E/ECE/324
E/ECE/TRANS/505 } Rev.1/Add.93/Amend.2

Addendum 93: Regulation No. 94

Amendment 2

UNIFORM PROVISIONS CONCERNING THE APPROVAL OF VEHICLES WITH REGARD TO THE PROTECTION OF THE OCCUPANTS IN THE EVENT OF A FRONTAL COLLISION

Figure 1

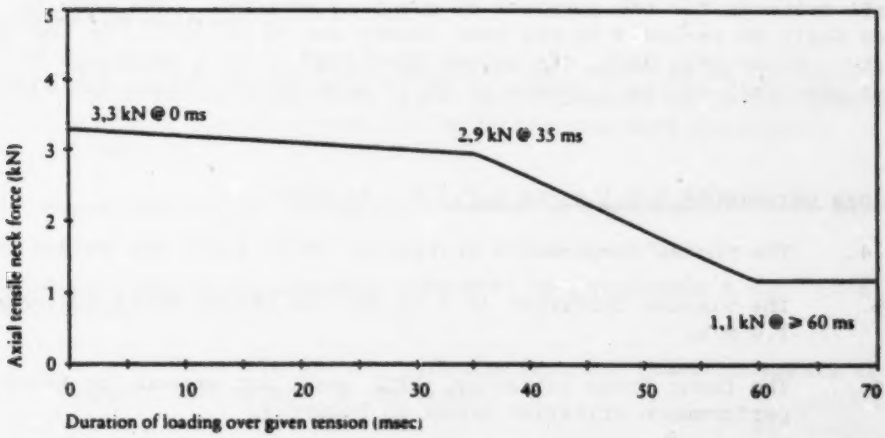
5.2.1.2. The neck injury criteria (NIC) shall not exceed the values shown in Figures 1 and 2 3/;

Figure 3

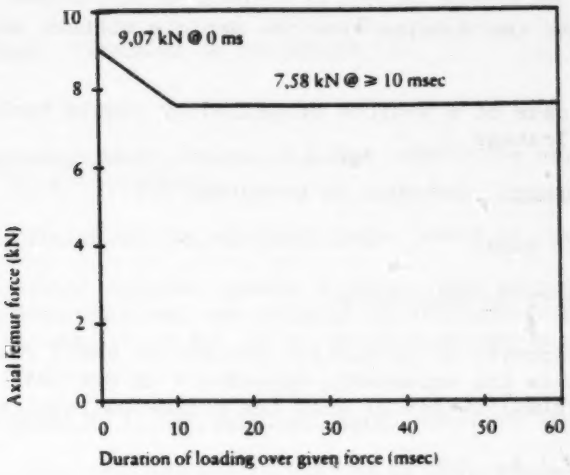
5.2.1.6. The femur force criterion (FFC) shall not exceed the force-time performance criterion shown in Figure 3;

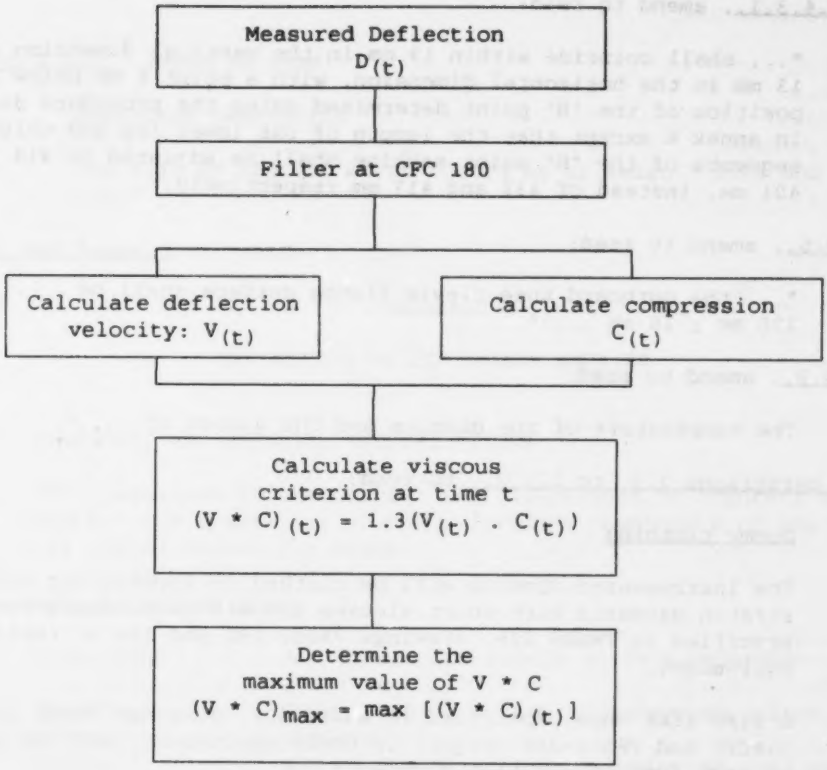
where $D_{(t)}$ is the deflection at time t in metres and ∂t is the time interval in seconds between the measurements of deflection. The maximum value of ∂t shall be $1,25 \times 10^{-4}$ seconds. This calculation procedure is shown diagrammatically below:

Figure 1

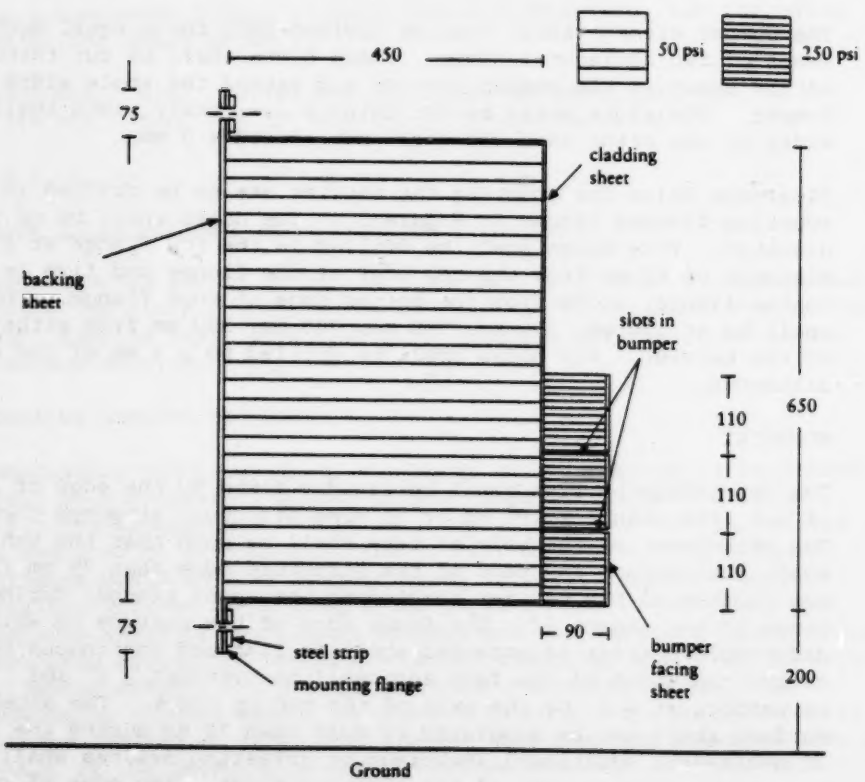
The dimensions of the barrier are illustrated in Figure 1 of this annex. The dimensions of the individual components of the barrier are listed separately below.

Figure 2

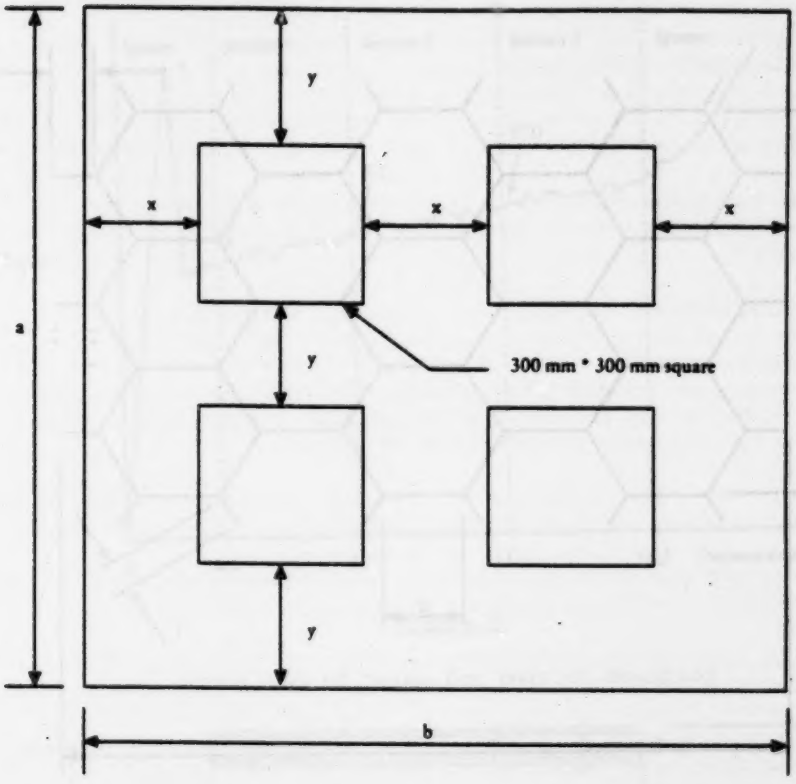
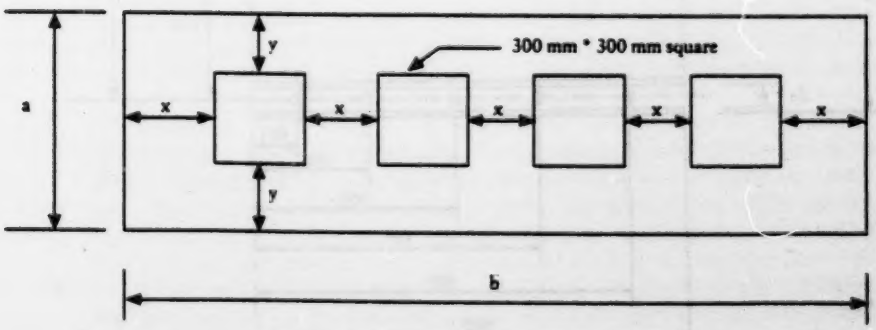
The location of the samples depends on the size of the honeycomb block. First, four samples, each measuring 300 mm x 300 mm x 50 mm thick shall be cut from the block of barrier face material. Please refer to Figure 2 for an illustration of how to locate these sections within the honeycomb block. Each of these larger samples shall be cut into samples for certification testing (150 mm x 150 mm x 50 mm). Certification shall be based on the testing of two samples from each

Figure 3

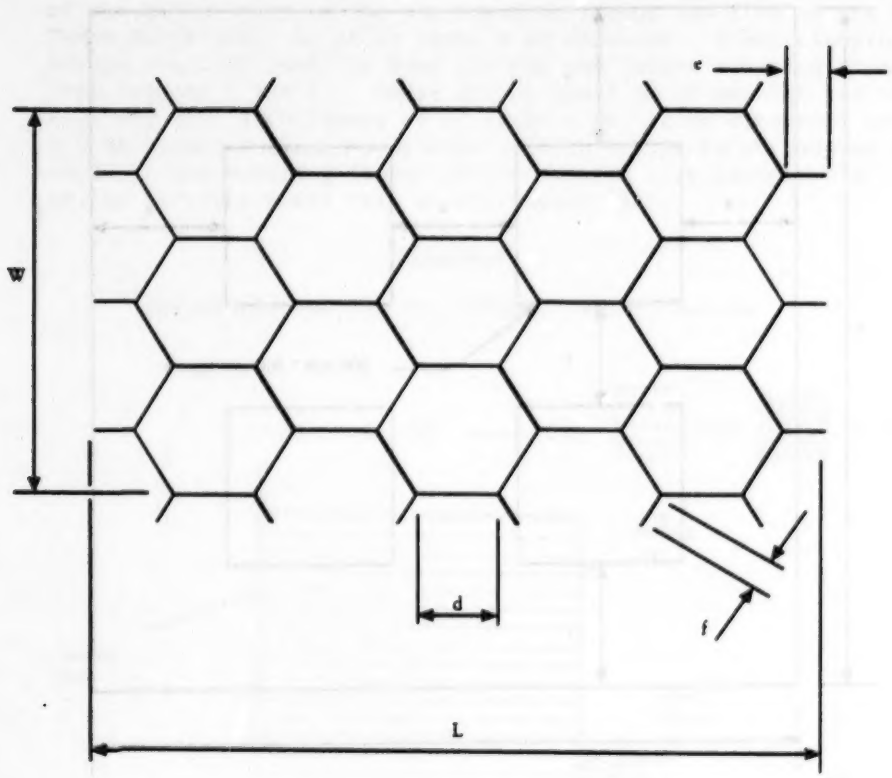
In the "W" direction, the fringes shall be no greater than 1.8 mm (see Figure 3).

In the "L" direction, half the length of one bonded cell wall (in the ribbon direction) shall be left at either end of the specimen (see Figure 3).

The length of the sample shall be measured in three locations, 12.7 mm from each end and in the middle, and recorded as L1, L2 and L3 (Figure 3). In the same manner, the width shall be measured and recorded as W1, W2 and W3 (Figure 3). These measurements shall be taken on the centreline of the thickness. The crush area shall then be calculated as:

Figure 4

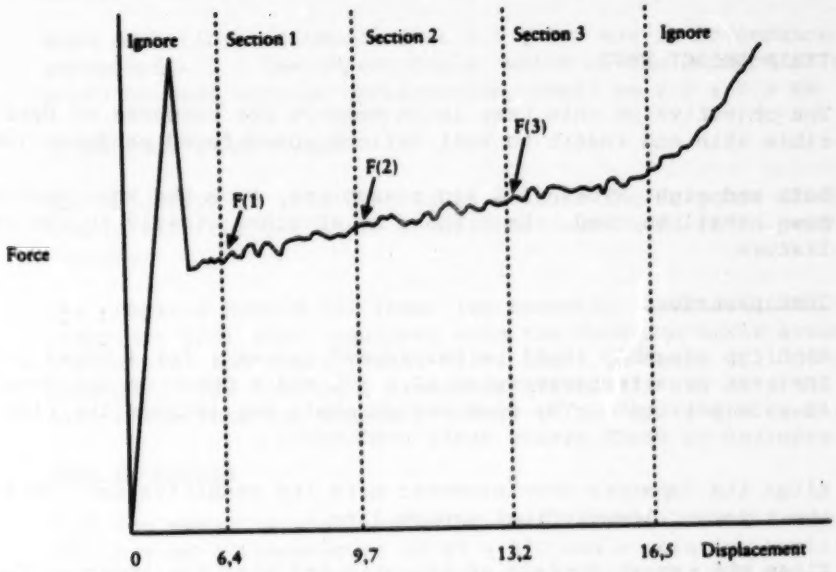
Ignore all data prior to 6.4 mm of crush and after 16.5 mm of crush. Divide the remaining data into three sections or displacement intervals (n = 1, 2, 3) (see Figure 4) as follows:

Figure 5

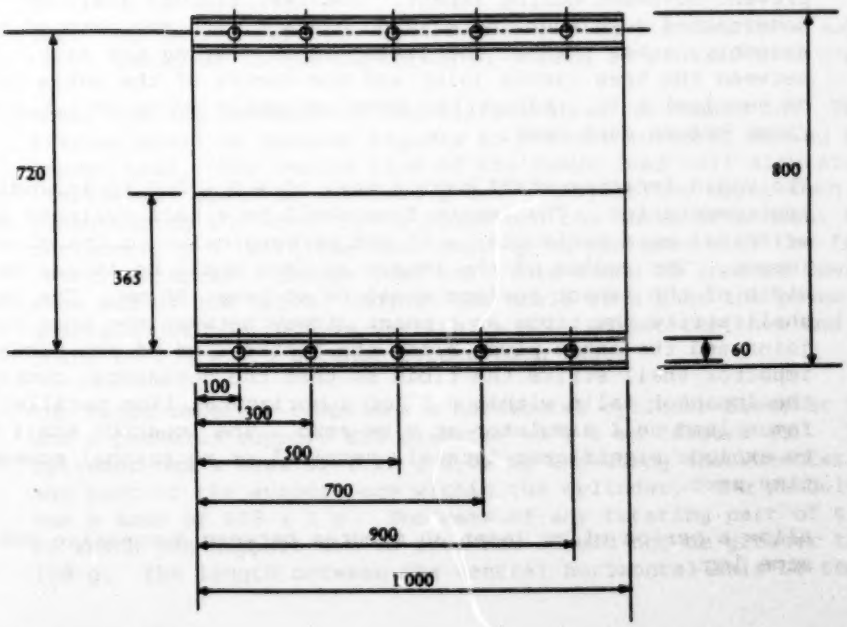
4.4. Clearance holes for mounting the barrier are to be drilled in the mounting flanges (shown in Figure 5). The holes shall be of 9.5 mm diameter. Five holes shall be drilled in the top flange at a distance of 40 mm from the top edge of the flange and five in the bottom flange, 40 mm from the bottom edge of that flange. The holes shall be at 100 mm, 300 mm, 500 mm, 700 mm, 900 mm from either edge of the barrier. All holes shall be drilled to ± 1 mm of the nominal distances.

Figure 1

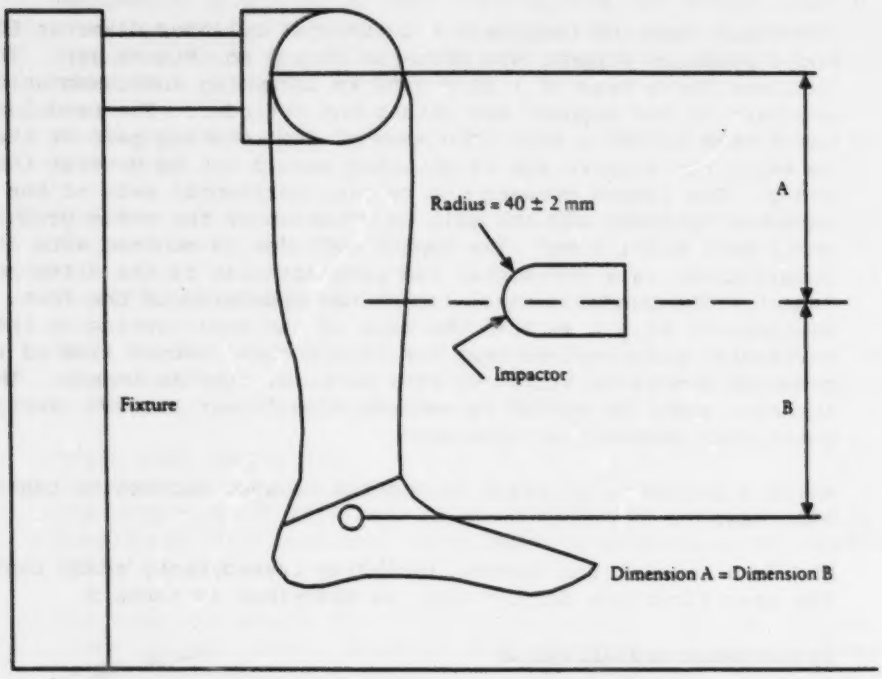
1.3.4. Mount the leg assembly to the fixture at the knee clevis joint, as shown in Figure 1. The text fixture shall be rigidly secured to prevent movement during impact. The test fixture shall be constructed such that there is no contact with any part of the leg assembly, other than at the fixing point, during the test. The line between the knee clevis joint and the centre of the ankle joint shall be vertical ± 5°. Adjust the knee and ankle joint to 1,5 ± 0,5 g range before each test.

Figure 1a

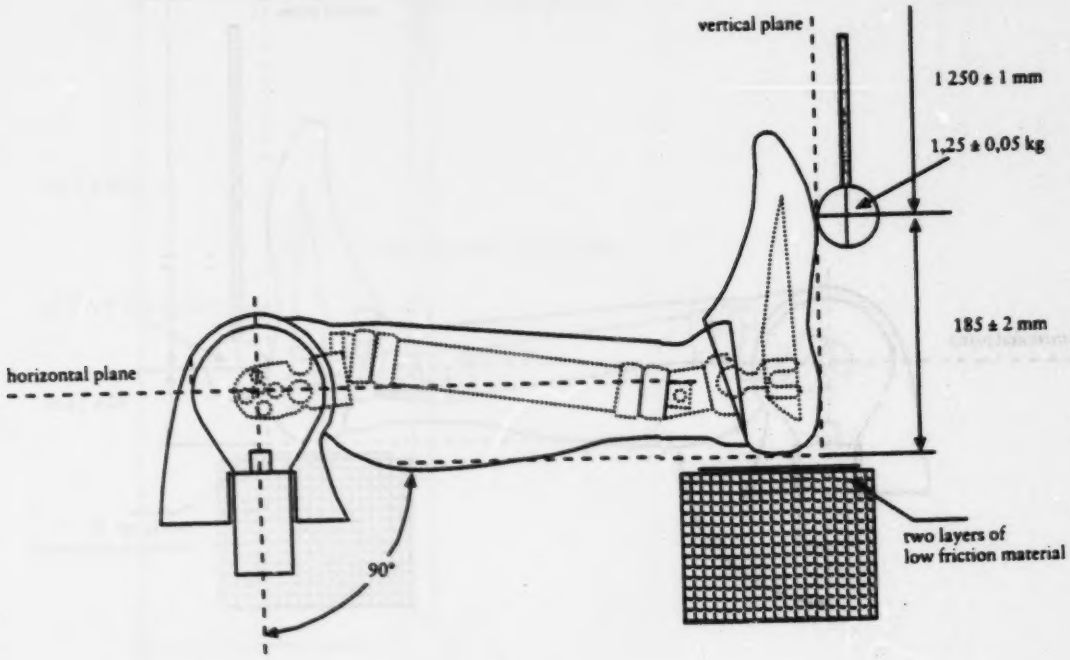
2.3.3. Mount the leg assembly to the fixture shown in Figure 1a. The test fixture shall be secured rigidly to prevent movement during the impact test. The centre line of the femur load cell simulator (78051-319) shall be vertical ± 0,5°. Adjust the mount such that the line joining the knee clevis joint and the ankle attachment bolt is horizontal ± 3° with the heel resting on two sheets of low-friction (PTFE) material. Ensure that the tibia flesh is located towards the knee end of the tibia. Adjust the ankle such that the plane of the underside of the foot is vertical ± 3°. Adjust the knee and ankle joint to 1,5 ± 0,5 g range before each test.

Figure 1b

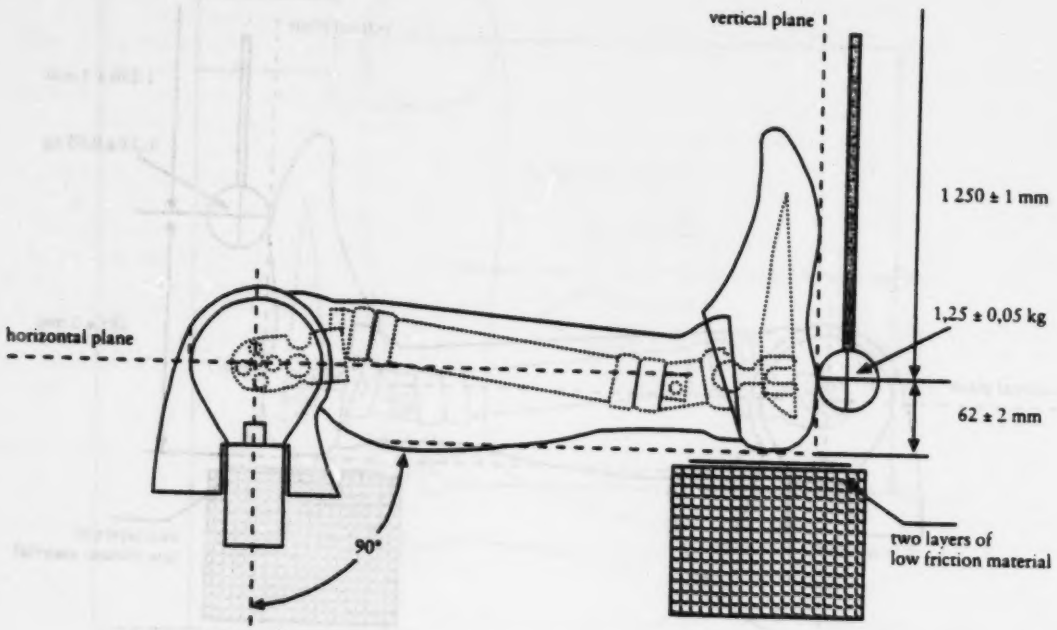
3.3.4. Mount the leg assembly to the fixture shown in Figure 1b. The test fixture shall be secured rigidly to prevent movement during the impact test. The centre line of the femur load cell simulator (78051-319) shall be vertical ± 0,5°. Adjust the mount such that the line joining the knee clevis joint and the ankle attachment bolt is

Figure 3a

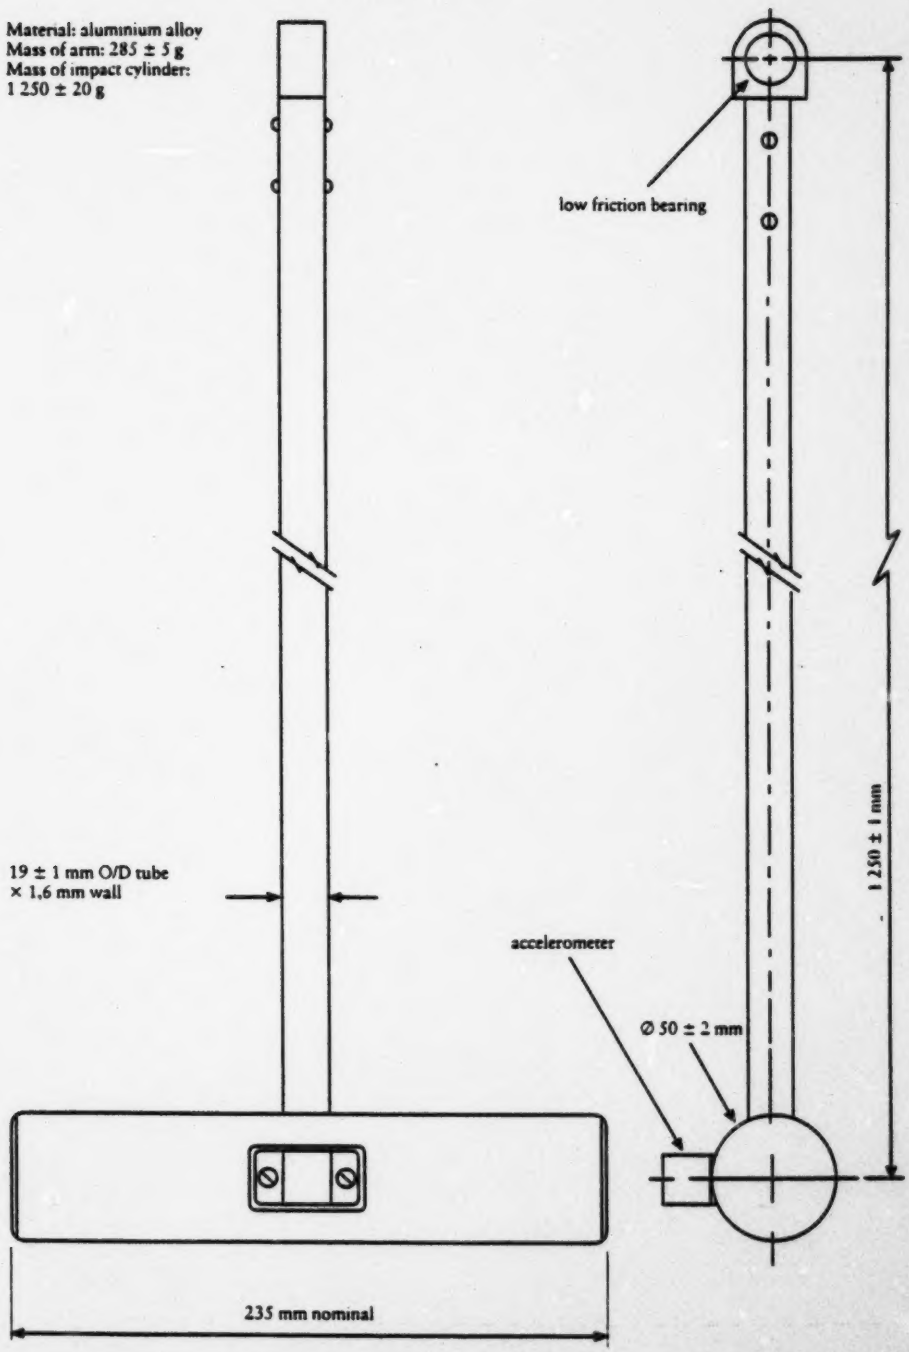
2.3.4. The rigid impactor comprises a horizontal cylinder diameter 50 ± 2 mm and a pendulum support arm diameter 19 ± 1 mm (Figure 3a). The cylinder has a mass of 1,25 ± 0,02 kg including instrumentation and any part of the support arm within the cylinder. The pendulum arm has a mass of 285 ± 5 g. The mass of any rotating part of the axle to which the support arm is attached should not be greater than 100 g. The length between the central horizontal axis of the

3.3.5. The rigid impactor comprises a horizontal cylinder diameter 50 ± 2 mm and a pendulum support arm diameter 19 ± 1 mm (Figure 3a). The cylinder has a mass of 1,25 ± 0,02 kg including instrumentation and any part of the support arm within the cylinder. The pendulum arm has a mass of 285 ± 5 g. The mass of any rotating part of the axle to which the support arm is attached should not be greater than 100 g. The length between the central horizontal axis of the impactor cylinder and the axis of rotation of the whole pendulum shall be 1 250 ± 1 mm. The impact cylinder is mounted with its longitudinal axis horizontal and perpendicular to the direction of impact. The pendulum shall impact the underside of the foot, at a distance of 62 ± 2 mm from the base of the heel resting on the rigid horizontal platform, so that the longitudinal centre line of the pendulum arm falls within 1° of a vertical line at impact. The impactor shall be guided to exclude significant lateral, vertical or rotational movement at time-zero.
